TG12.1 – Civil/Sitework at Grade/Ground Level Landscaping

Questions are numbered in the order received. Numbers missing in the sequence either have been answered in a previous response set or will be answered in a future set.

Based on Sheet C1-6002

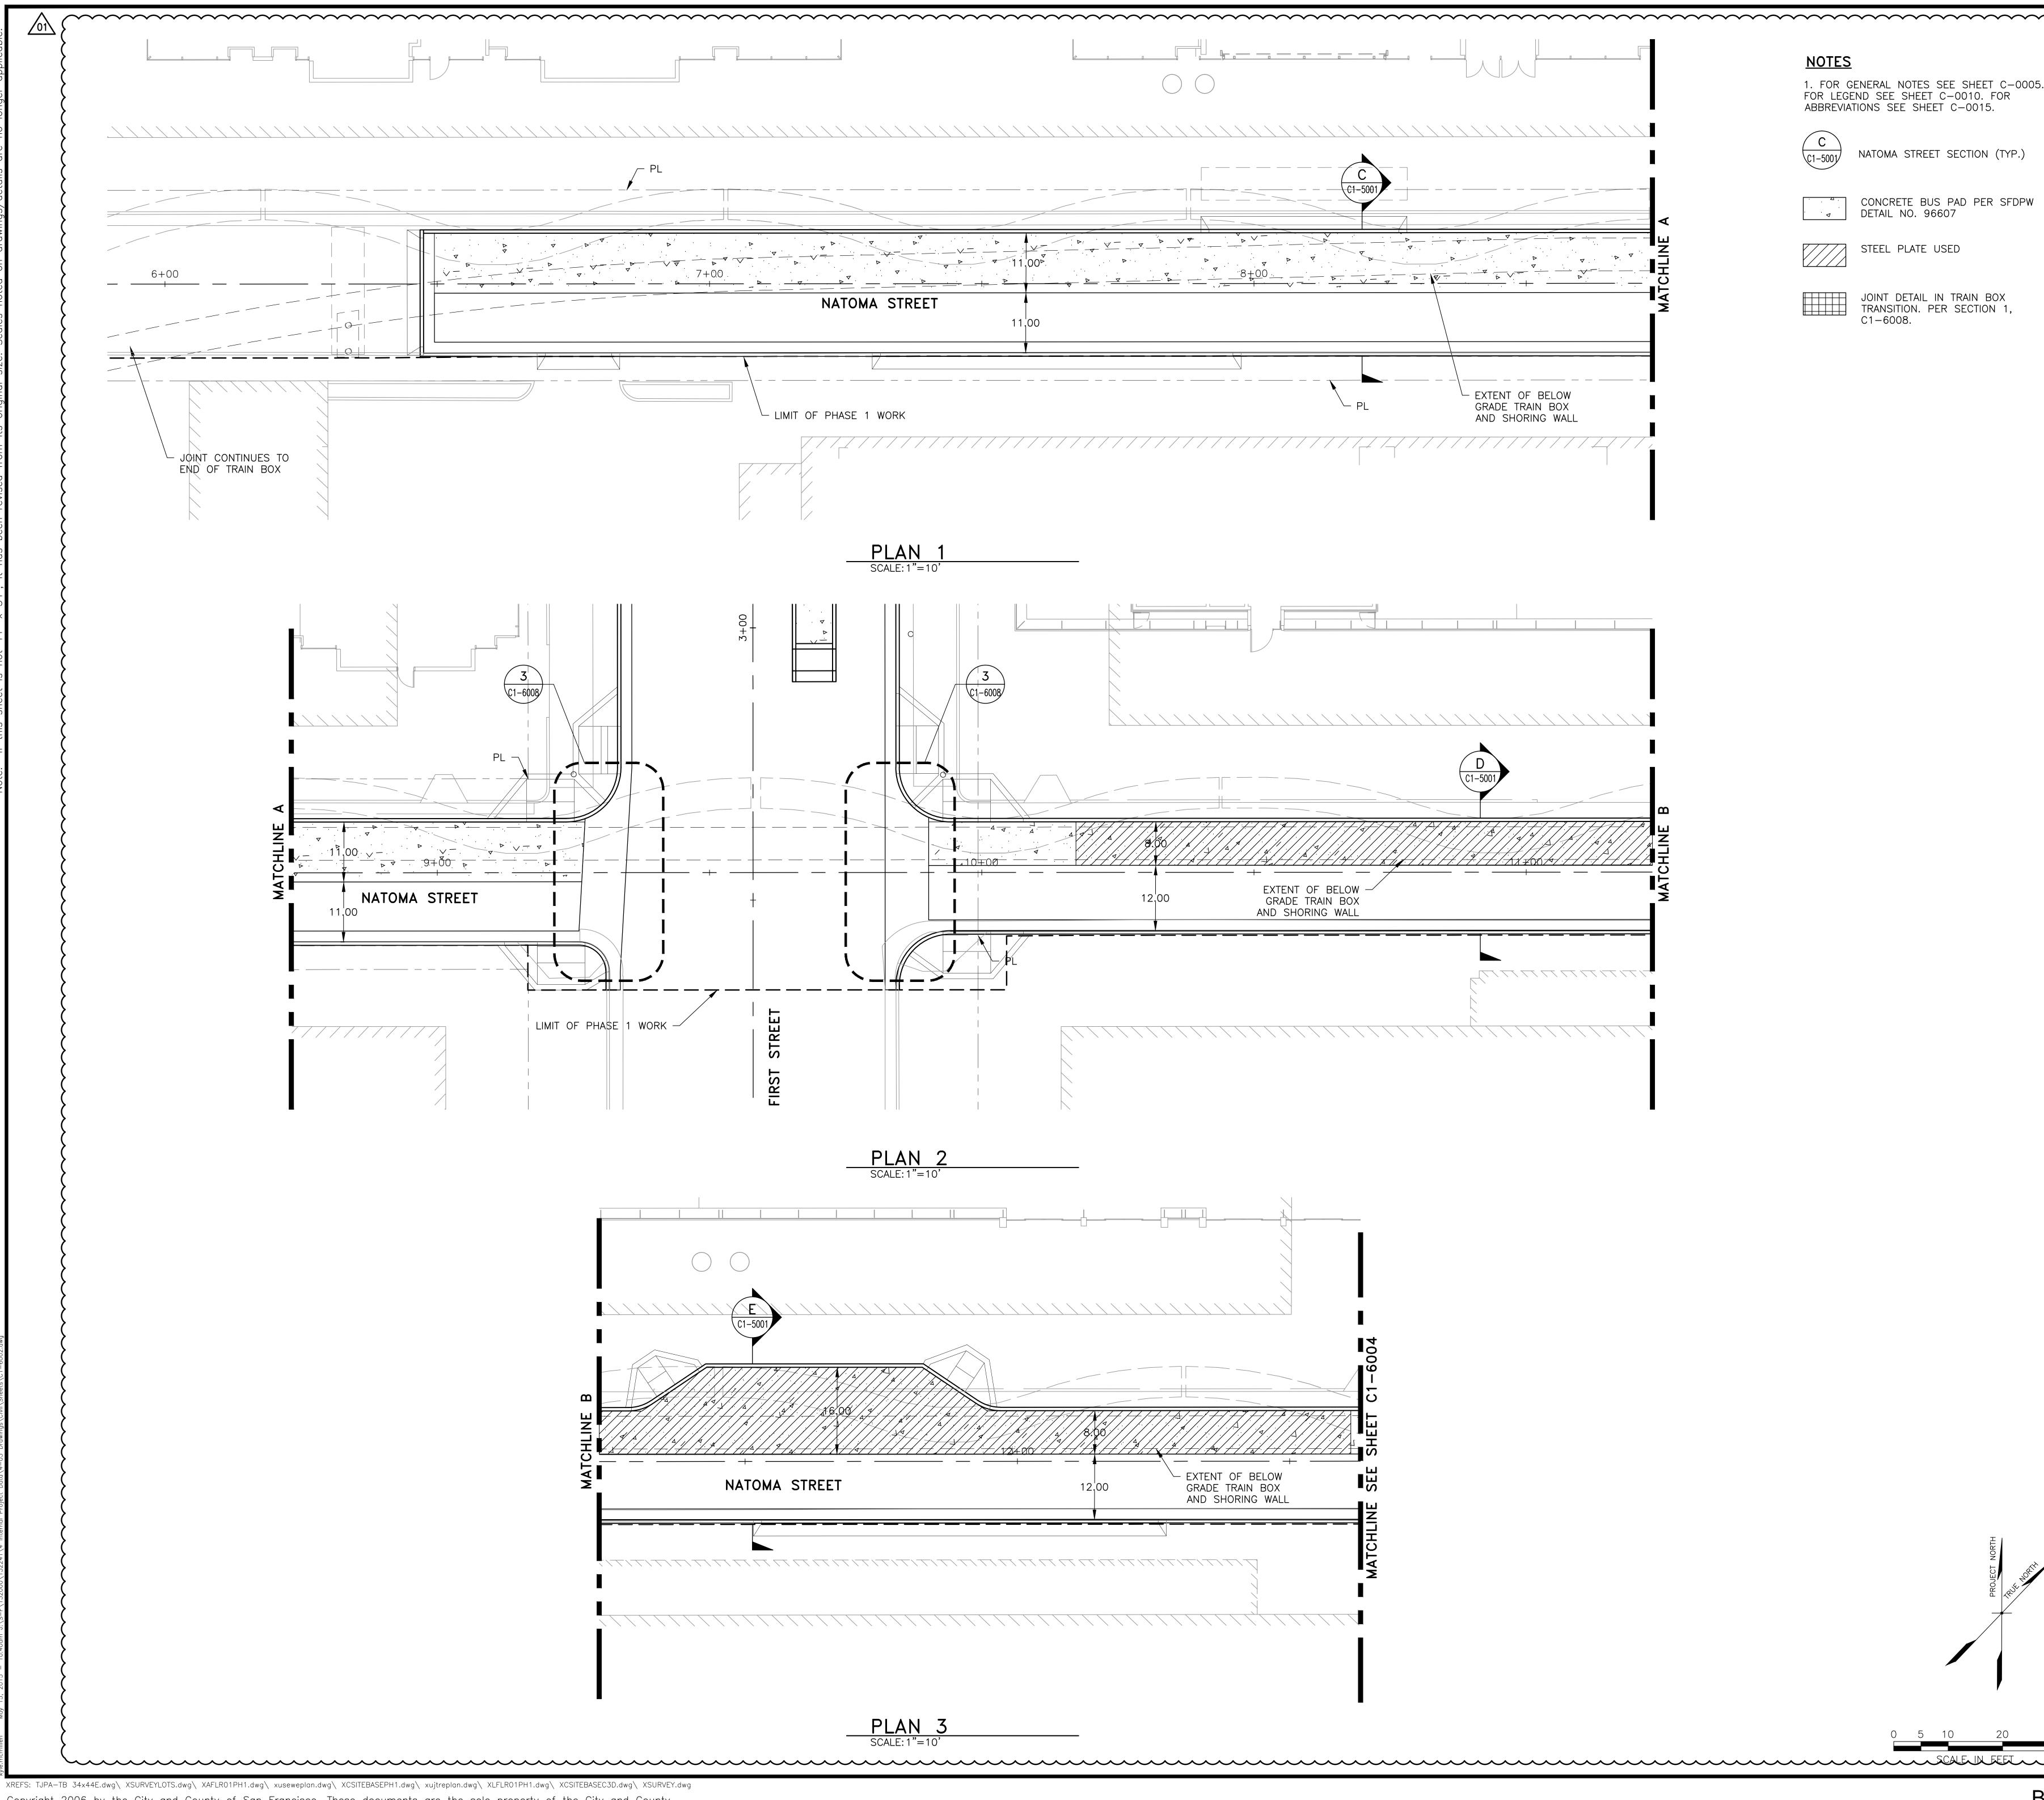
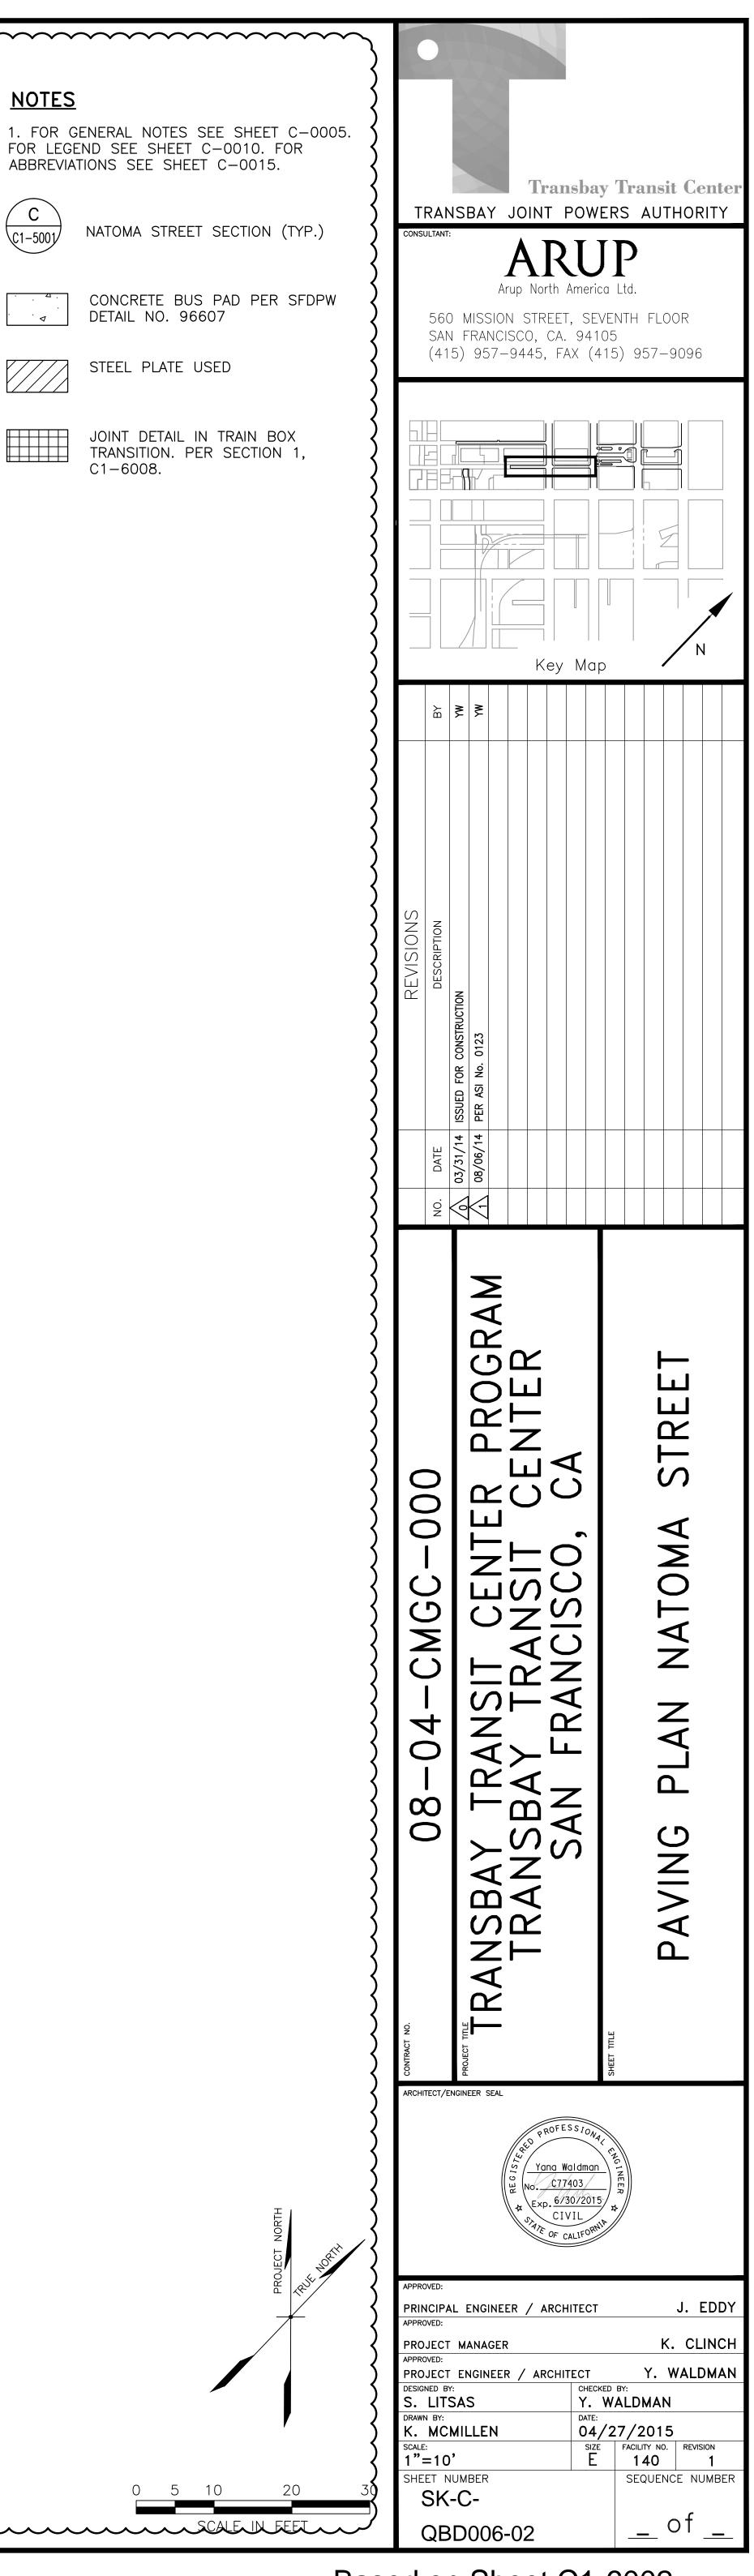
Question No.	Submission Date	Drawing No.	Document/ Spec. No.	Question	Response
TG12.1- 001	5/7/2015	C1- 2000s, C1- 4000s, C1- 5000s		Plan Sheets C1-200x, C1-400x, C1-500x (x = various numbers) graphically show curbs without gutter sections. This is consistent with Note 4 on the various C1-500x sheets, which refers to 6" Curb per SFDPW Std #87169. But the Paving Plans (Sheets C1-600x) graphically indicate that the curb adjacent to the typical street buildup sections (C1-6008) is a curb and gutter section, as depicted on SFDPW Std #87170, rather than curb-only. Please clarify.	Curb and gutter to be provided as shown graphically in the Paving Plans (Sheets C1- 600x). Refer to SFDPW Std #87170 for curb and gutter sections.
TG12.1- 006	5/7/2015	C1-6008 & C1- 5001-C1- 5005		Plan Sheet C1-6008 shows that 1/4" steel plate is to be used in lieu of 6" of sub-base when 6" isn't available. How do we determine where the steel plate will be required? Plan Sheets C1-5001 thru C1-5005 indicate that much of the street area over the box is very close to this 6" minimum, and the cost differential between steel and sub-base is significant.	For clarification of steel protection plate locations, please refer to attached Civil Sketches QBD006-01 through QBD006-05. Steel plate is not part of TG12.1 scope.

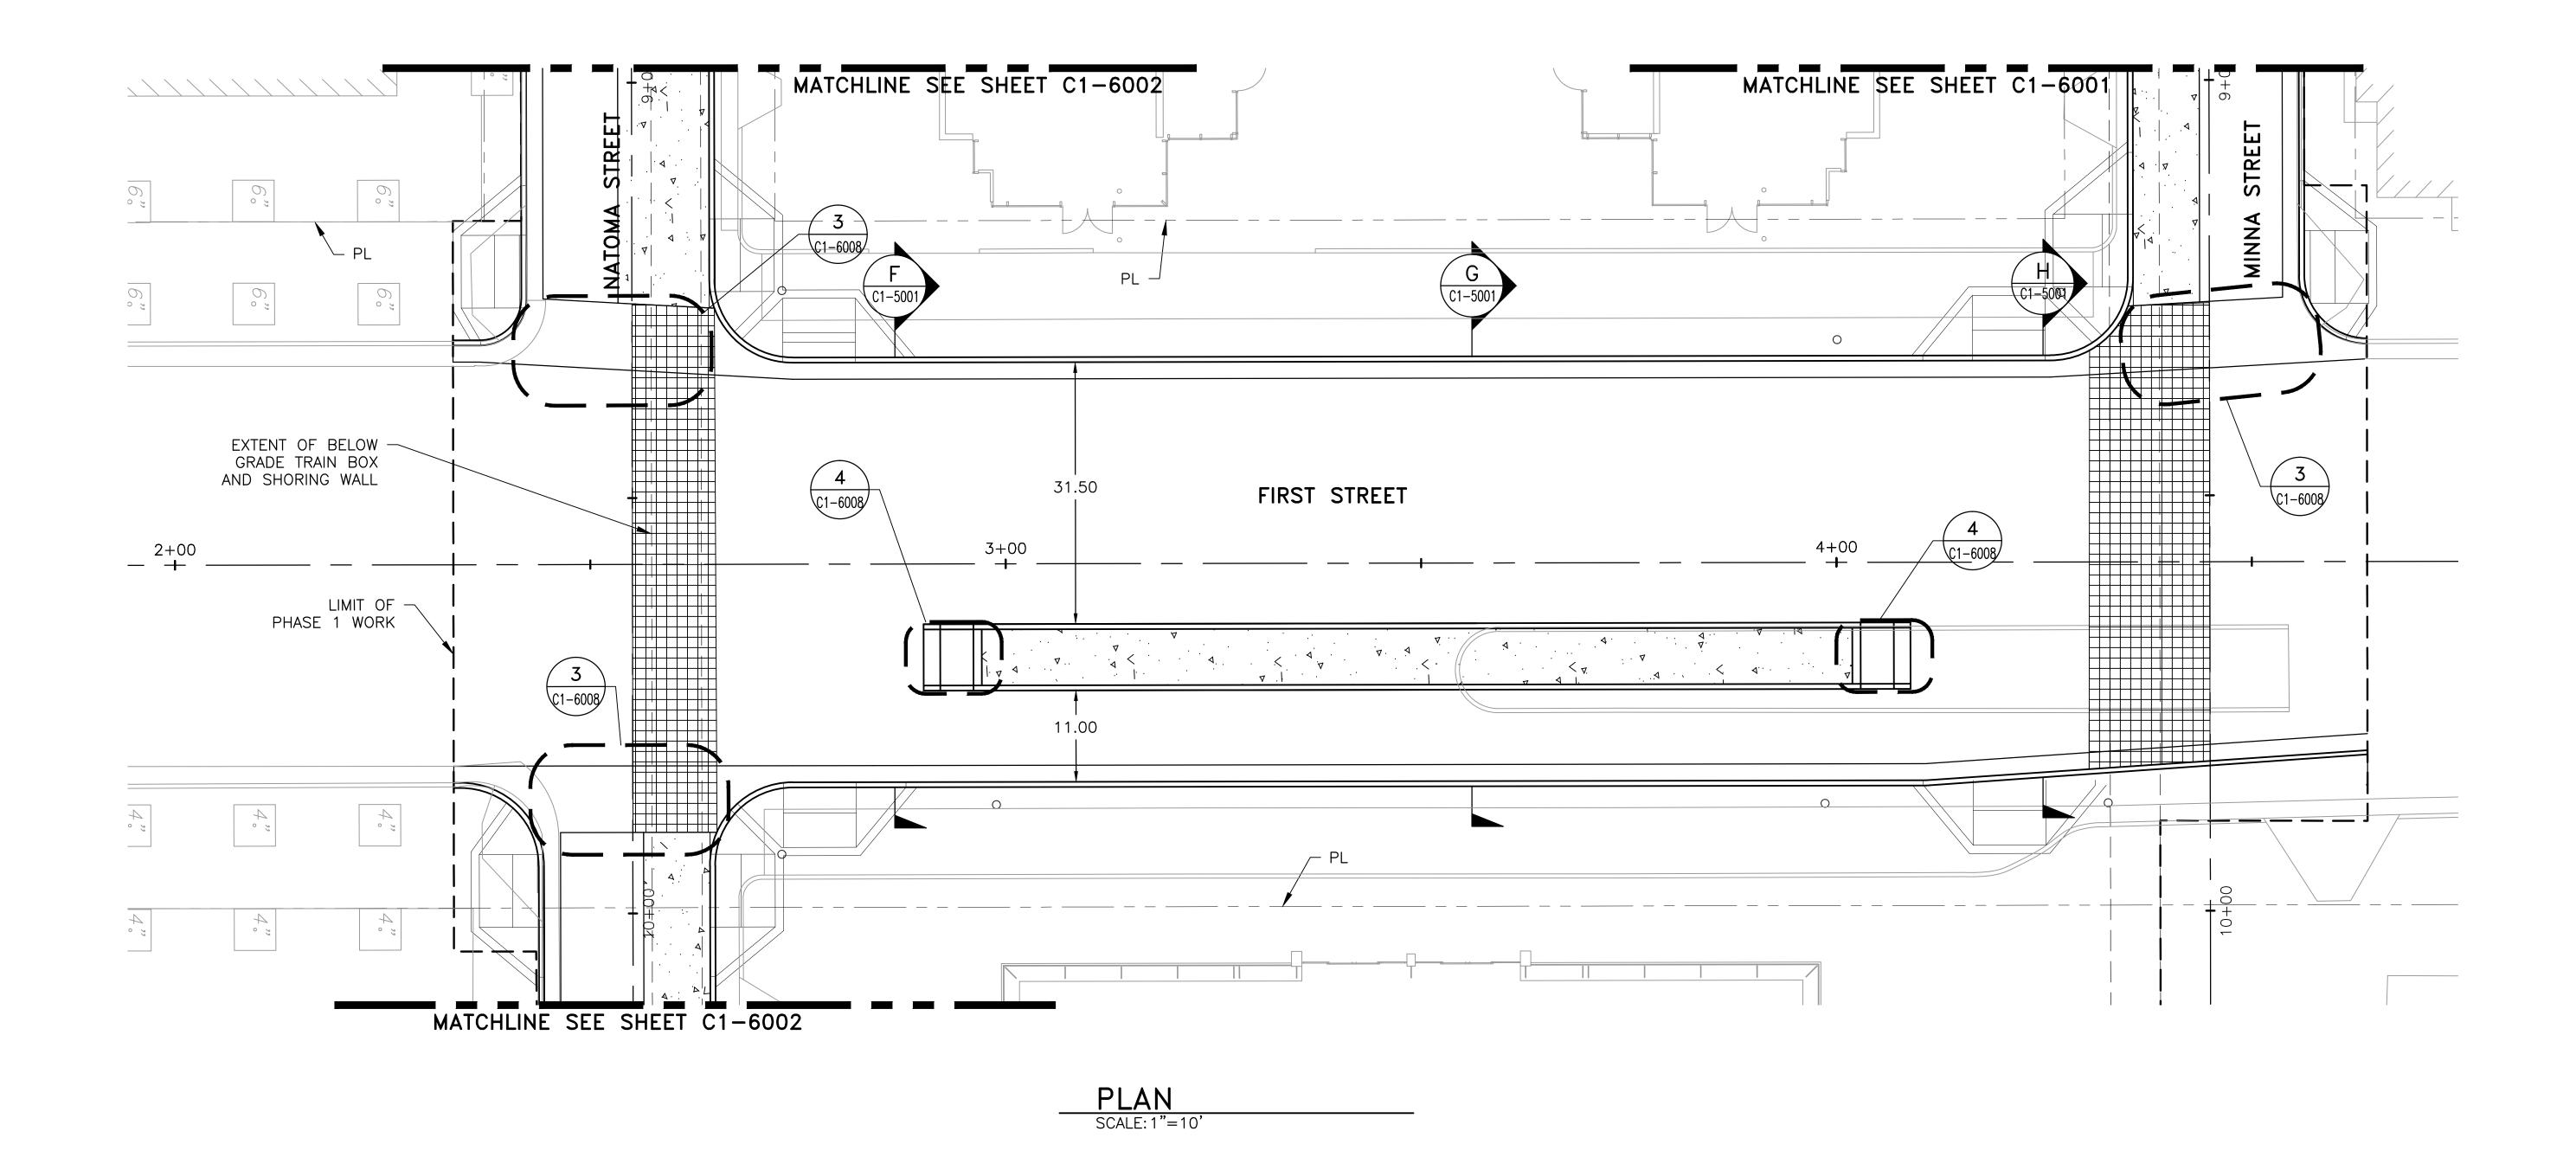
TG12.1- 007	5/7/2015	C1-6008 & C1- 5001-C1- 5005		In areas referenced in drawings that require steel plate, what (if anything) is placed between the steel plate and concrete base?	No additional construction material is required to be placed between the steel plate and the concrete base.
TG12.1- 009	5/7/2015			Is special fill (i.e. lightweight) required for the permanent street fills between the TOTB and pavement sections at First, Fremont, and Beale streets?	There is no special fill/lightweight fill required along First, Fremont, and Beale streets between TOTB and the pavement section; standard fill is acceptable.
TG12.1- 012	5/7/2015	C1-6008, C1-5002		The permanent roadway sections at First, Fremont, and Beale streets (per C1-6008) include 2" of AC over variable thickness concrete base and 6" of sub-base, over an undefined material under the sub-base. Also, Page 10 of 13 (in TG12.1 document) includes a note to "include section of structural concrete per detail C1-5002" There is no structural concrete noted on C1- 5002, or the noted/referenced C1-6008 sections. Should this be "concrete base"? This section does not match the sections placed in the Bridge Removal Plans.	The "TG12.1 First and Fremont St. Removal" document is for reference only. The note to "include section of structural concrete per detail C1-5002" on Pg. 10 is meant to refer to the "concrete base" callout as shown on C1- 6008.
